ADDENDUM NO. THREE

DATE: May 13, 2013

PROJECT: Library-Atascadero-Library Expansion 320030
General Government-North County-One Stop Service Center

SK-1
ADD#3

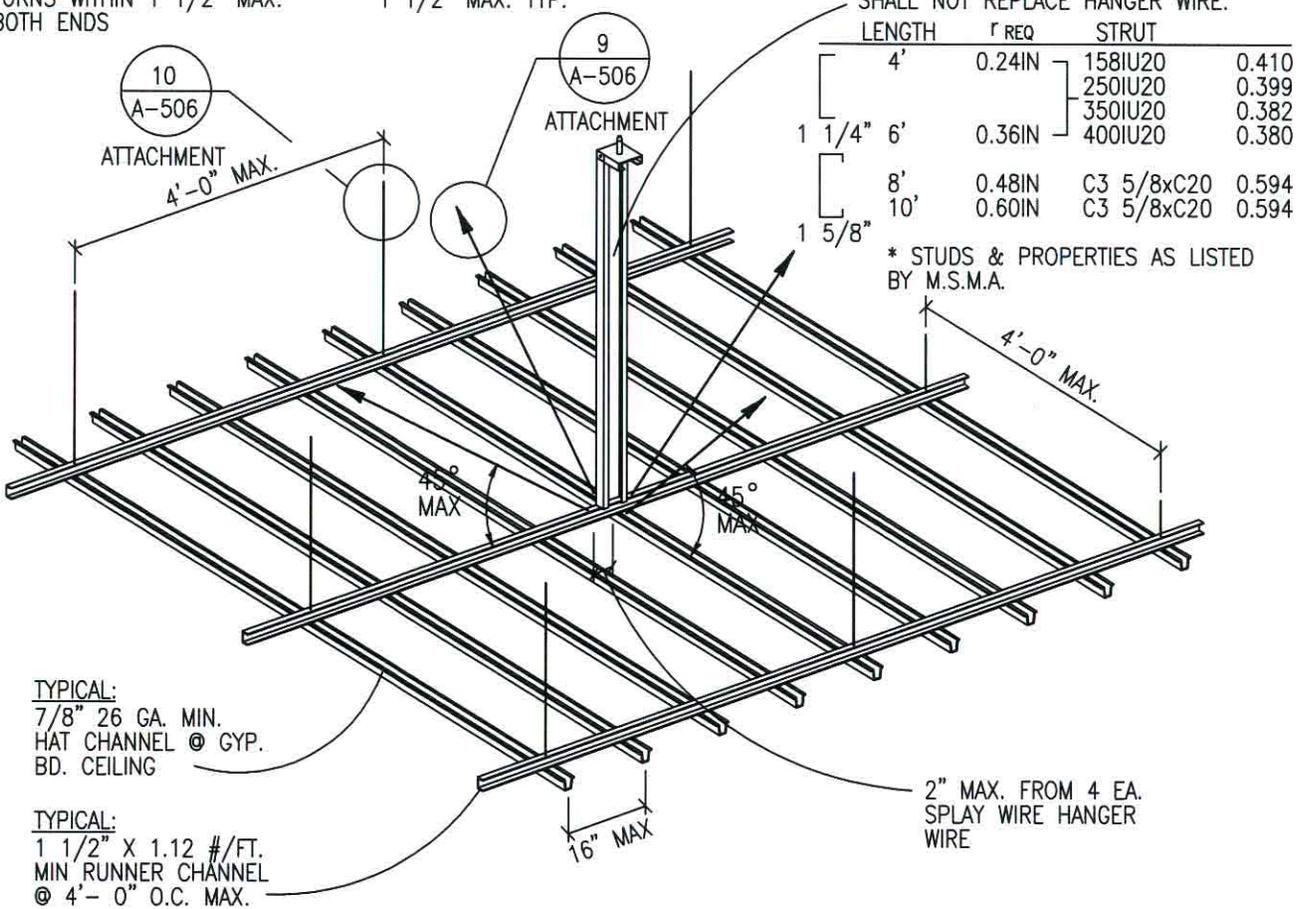
Note 1.14 on Clarification Notes – Document 1 indicates all ceilings including gyp board ceilings shall be suspended..“There are no wood framed ceilings.” The Gypsum Board spec section 092900 1.2.B refers to Division 6 for ...framing support for gypsum board panels which conflicts with the clarification note.

In addition I cannot find a specification section for the drywall suspension system.

14. Soffits are framed per details called out on A3.1 & A3.2 and details referenced to A8.3. Suspension system for the gypsum board ceiling shall be per the attached detail SK-1. (RFI # 7, Carroll Building Co.)

8 GA. WIRE MAX.
SPAN 4'x3' (12 S.F.)
W/ FURRING @ 16" O.C.
8 GA. WIRE MAX.
SPAN OF 4'x4' (16 S.F.)
W/ FURRING @ 12" O.C.
ALL HANGER WIRE W/ 3
TURNS WITHIN 1 1/2" MAX.
BOTH ENDS

12 GA. MIN. SEISMIC BRACE
SPACED @ 8' X 12' MAX. AND
WITHIN 6'- 0" OF WALL.
PROVIDE CONNECTION BETWEEN
DIAGONAL WIRES AND MAIN
RUNNER TO PREVENT SLIPPING
W/ 4 TIGHT TURNS WITHIN
1 1/2" MAX. TYP.

STEEL SECTION WITH L/R RATIO OF
200 MAX. STARTING NOT MORE THAN
4'- 0" FROM ADJACENT WALLS TO
SUPPORT A TRIBUTARY AREA OF
144 S.F. ATTACH TO MAIN RUNNER
WITH 1/4" MACHINE BOLT AND TO
STRUCTURE. COMPRESSION STRUT
SHALL NOT REPLACE HANGER WIRE.

A3.1

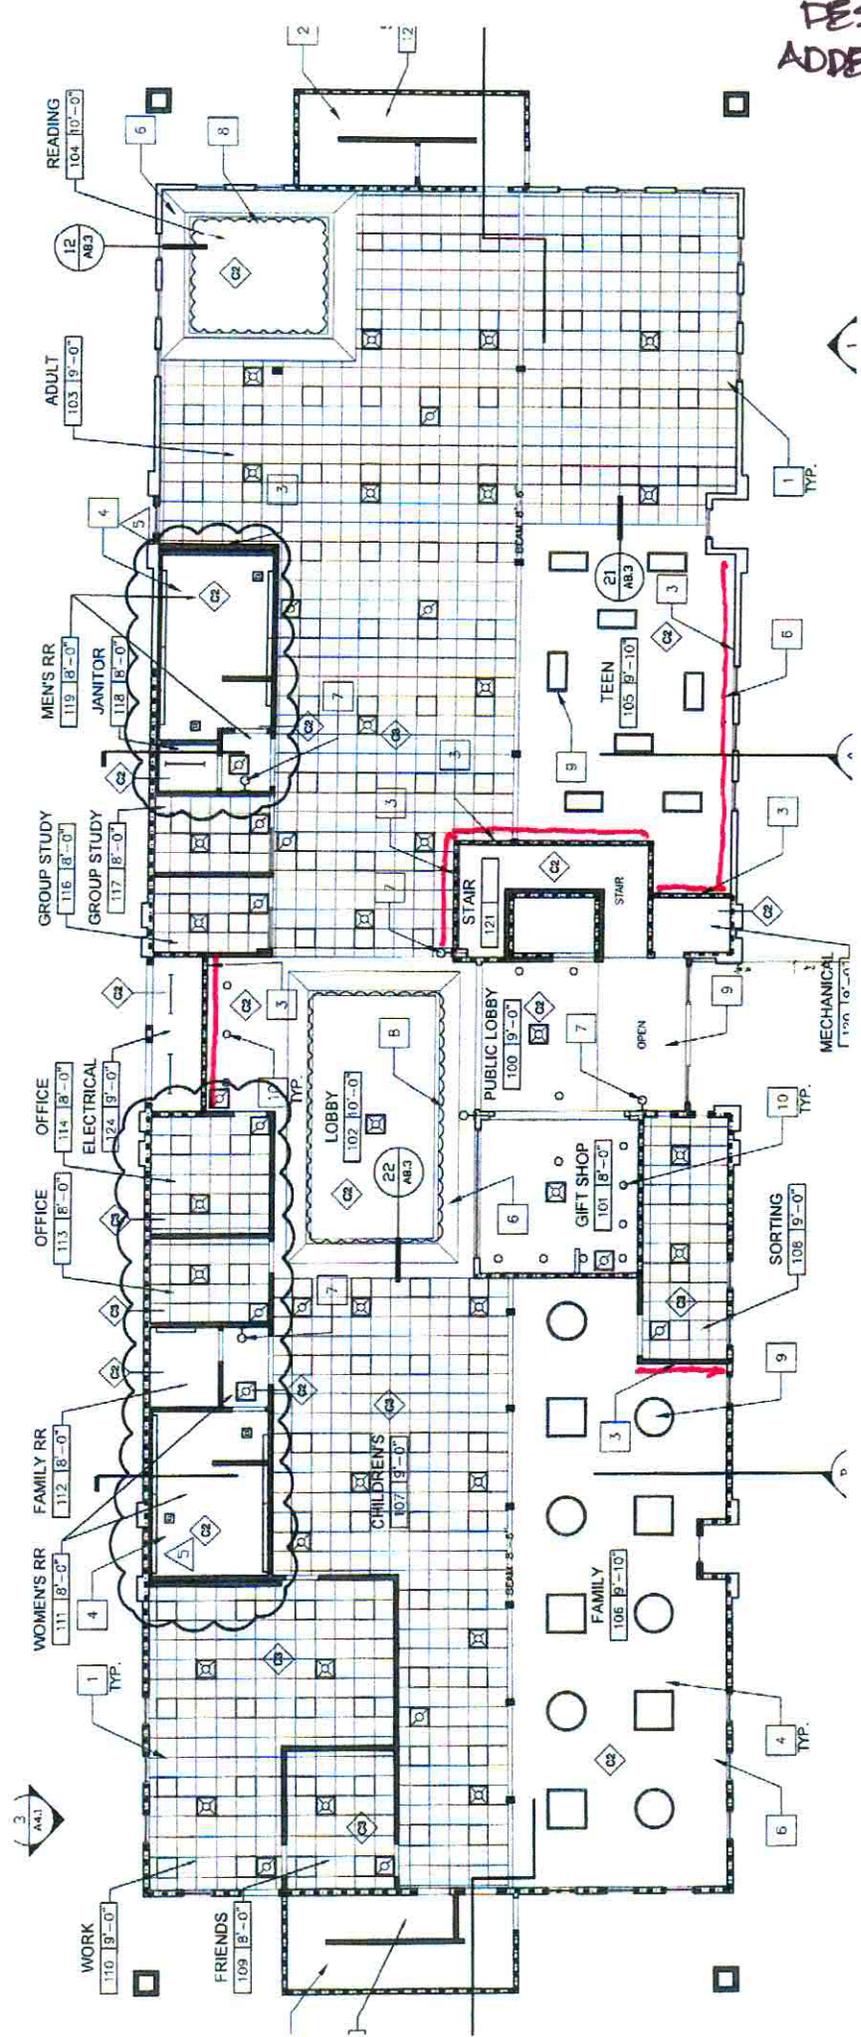
I am trying to determine the extent of the installation of the Aluminum Picture Rail by Art Hanging Systems. I have attached the first and second floor reflected ceiling plans with the wall lines indicated in red where I see the picture hanger system indicated. Can you please check and verify the walls that receive this detail

3. Keynote #3 on sheets A3.1 and A3.2 shows the extent of the artwork hanging system. The General Contractor is responsible to provide the artwork hanging system at the locations shown on the drawings. RFI #1, Carroll Building Co.)
